Preliminary Consultation
MONTGOMERY COUNTY HISTORIC PRESERVATION COMMISSION
STAFF REPORT

Address:	19 Montgomery Avenue, Takoma Park	Meeting Date:	3/23/2022
Resource:	Outstanding Resource Takoma Park Historic District	Report Date:	3/16/2022
Applicant:	Marwan Hishmeh (Richard J Vitullo, Architect)	Public Notice:	3/9/2022
Review:	Preliminary Consultation	Tax Credit:	N/A
		Staff:	Michael Kyne

PROPOSAL: Screened porch addition, after the fact parking pad in front yard, door alteration, after the fact basement window and door alterations, foundation re-parging

Fig. 2: 1927 Sanborn Fire Insurance Map, with subject property outlined in red.

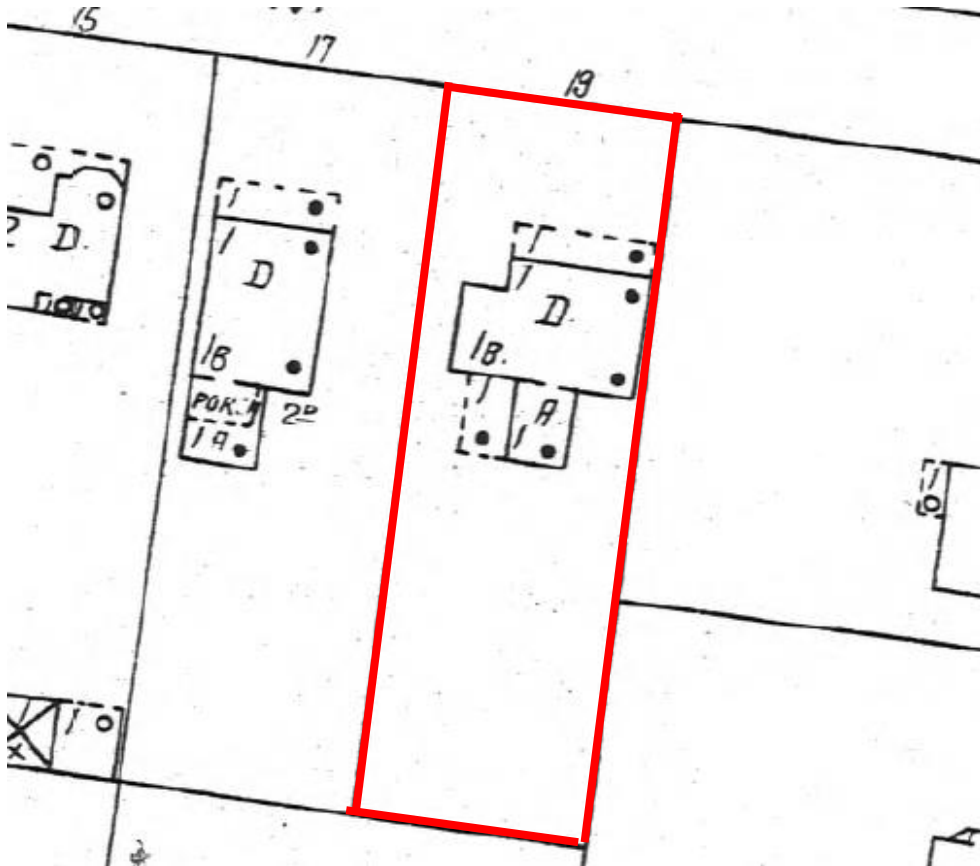
The subject property is a c. 1910s-20s Bungalow-style Outstanding Resource within the Takoma Park Historic District. There is an original one car attached garage at the south/rear basement level, which was previously expanded, with an addition above. There is also an attached shed at the rear basement level on the west (right, as viewed from the public right-of-way of Montgomery Avenue) side of the garage. The 1927 Sanborn Fire Insurance Map indicates that there was originally a full length one story open structure in the location of the attached shed (*Fig. 2*).

EXIST. (+ PROPOSED) FRONT ELEVATION
 1/4" = 1'-0"

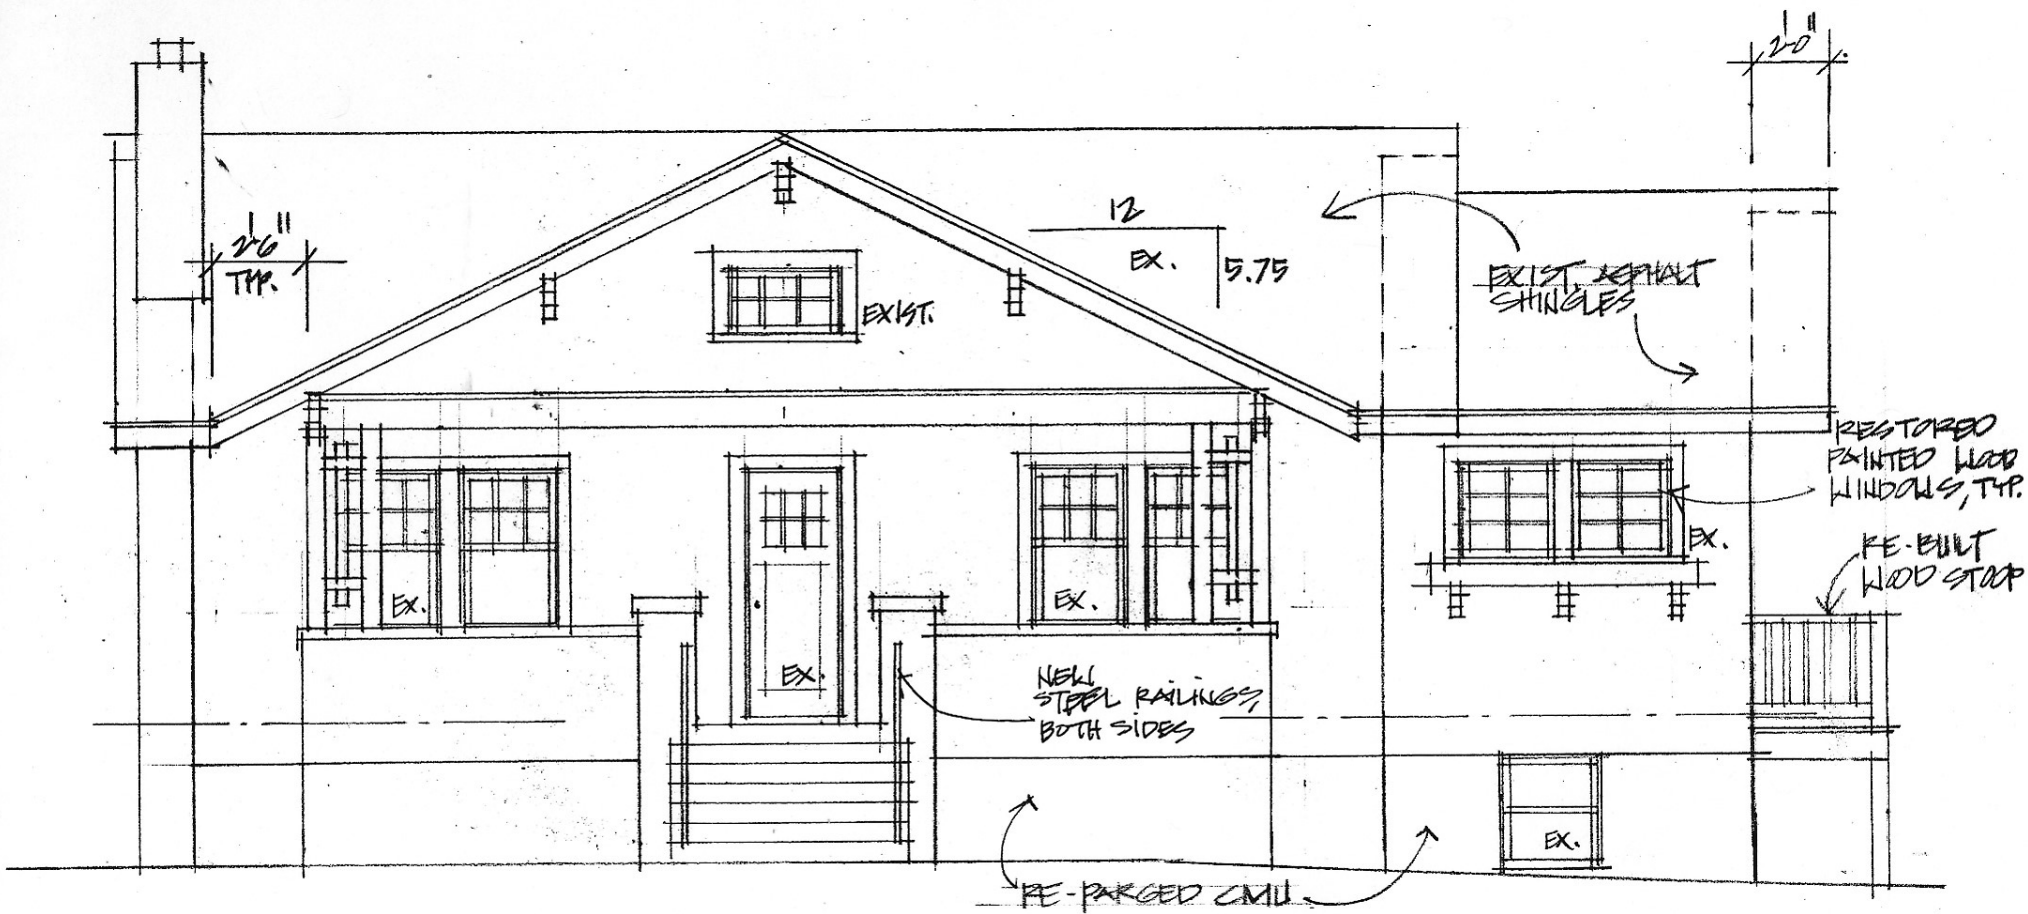
Staff notes that they would not have supported the new basement level windows on the front porch. While the Commission typically exercises greater leniency for basement level fenestration alterations on secondary elevations, the windows in question were on the primary elevation, where they were highly visible, and they altered the original front porch, a significant character-defining feature of the subject property.

Staff notes that they would not have supported the parking pad at the front of the property, as front parking pads are incompatible with the surrounding streetscape and with the historic district as a whole.

- Staff asks that the Commission concur/reiterate that the previously proposed basement level windows on the front porch and front parking pad are incompatible with subject property and surrounding streetscape, and that the applicant should sufficiently demonstrate that these unpermitted work items have been appropriately mitigated.
- Are there any outstanding concerns with the current proposal?

PROPOSED REAR ELEVATION
 1/4"=1'-0"

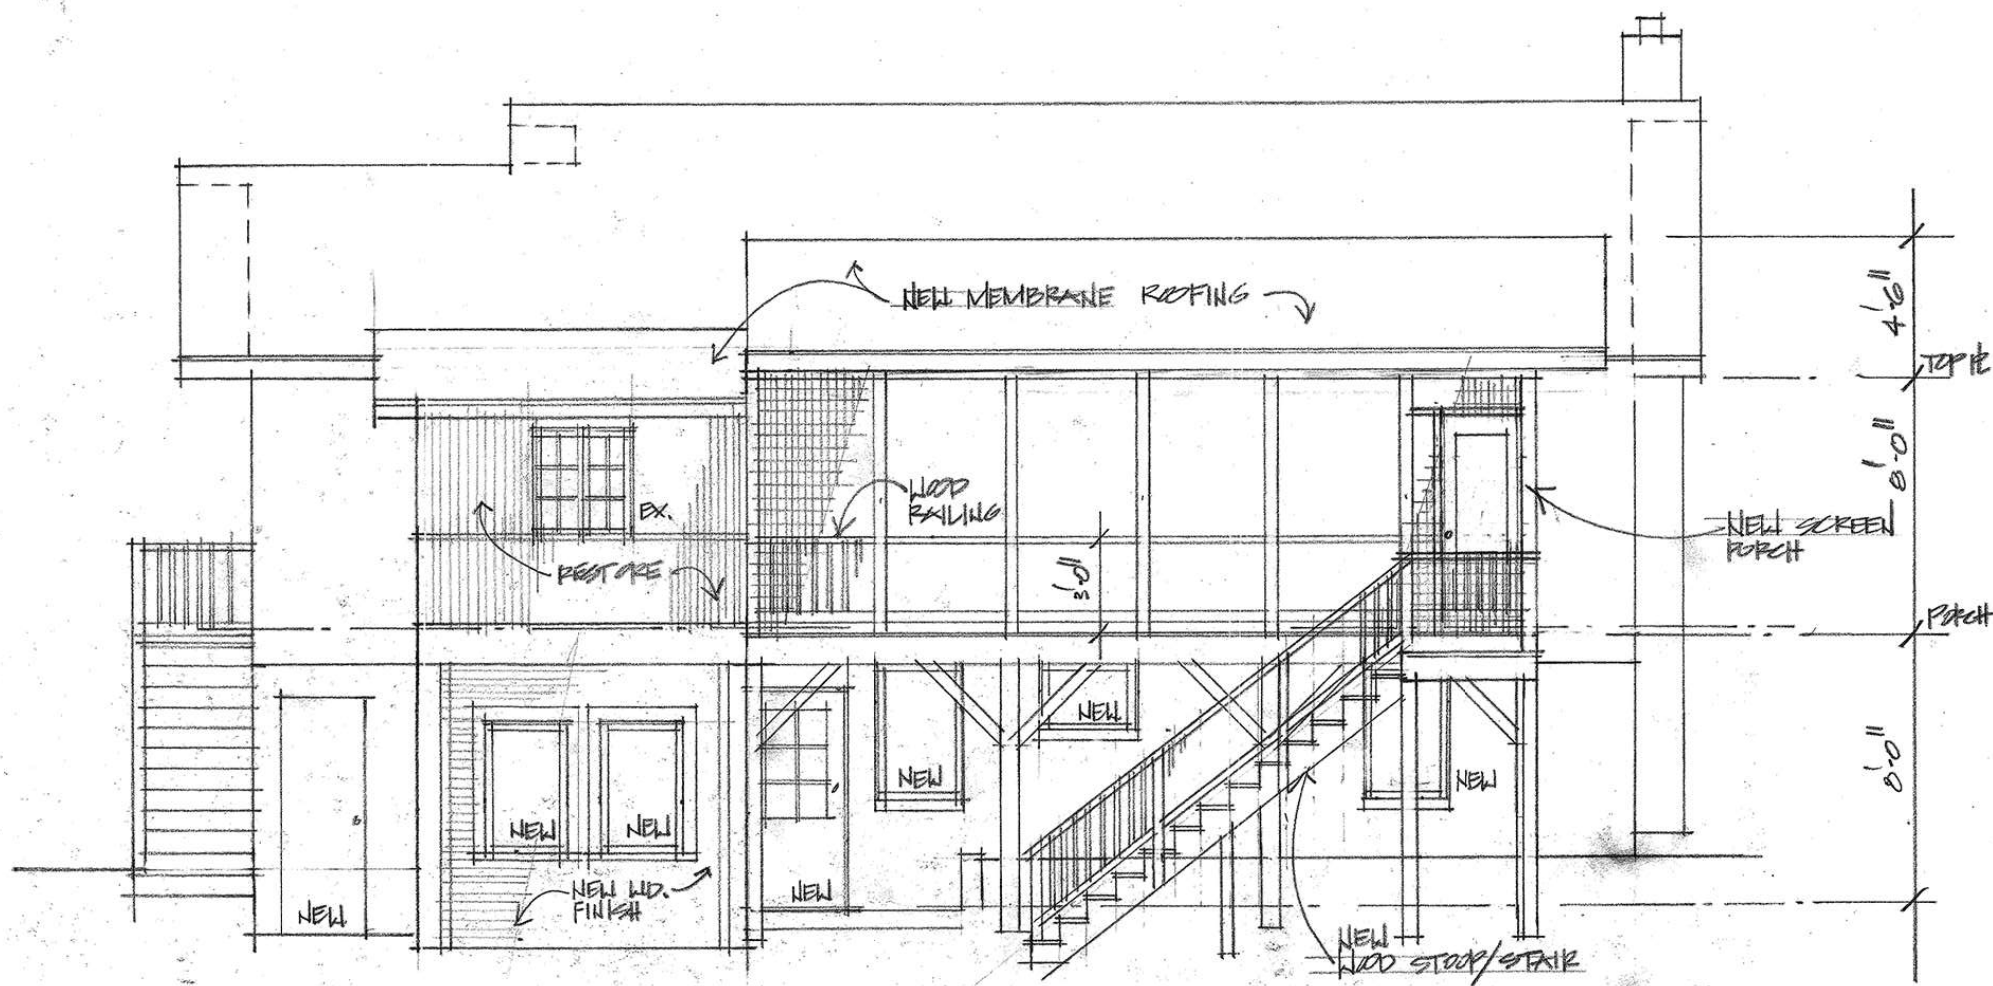
The windows and doors that are proposed to be replaced are at the basement level on the rear and secondary elevations, where the Commission typically exercises greater leniency in their review. Staff also finds that the proposed south/rear fenestration alterations will not be visible from the public right-of-way. As stated in the *Guidelines*, "[t]he design review emphasis will be restricted to changes that are at all visible from the public right-of-way, irrespective of landscaping or vegetation". Likewise, the proposed east/left side fenestration alterations will be negligibly visible, at best, due to the house's proximity to the east/left property line and an existing fence in that location.

Regarding the original window to be infilled on the first floor of the south/rear elevation, staff finds that this alteration will not be visible from the public right-of-way, and it will not significantly detract from the character of the subject property, even with its designation as an Outstanding Resource.
